| APPLICATION NO. | FILING DATE | FIRST NAMED INVENTOR | ATTORNEY DOCKET NO. | CONFIRMATION NO. |
|---|-------------|----------------------|---------------------|------------------|
| 10/681,832 | 10/08/2003 | Ralph A. Graf | LZ-79 | 6604 |

Office Action Summary

Hollingsworth et al. a sawtooth wire for producing all-steel sawtooth clothing for a doffer and/or a doffing cylinder of a carding machine, the sawtooth wire comprising a plurality of teeth 315 successively arranged in a longitudinal direction of the wire, each tooth having a tooth breast beginning at a tooth bottom and extending in a direction toward a tooth tip (Figures 7 and 8), and a tooth back that is connected with the tooth breast by two tooth flanks extending parallel to the longitudinal direction of the wire and extends from the tooth tip in a

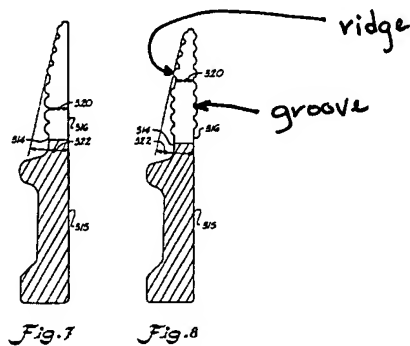
direction of a tooth bottom of a following tooth, at least one of the tooth flanks having at least one profile segment located between the tooth tip and the tooth bottom and provided with profiling (see figures below).

With regard to claim 2, the profile segment has at least one of at least one profile ridge and at least one profile groove (see figures above).

With regard to claim 10, a flat transition segment is located between at least two adjacent profile ridges or grooves of the profile segment (see figure above).
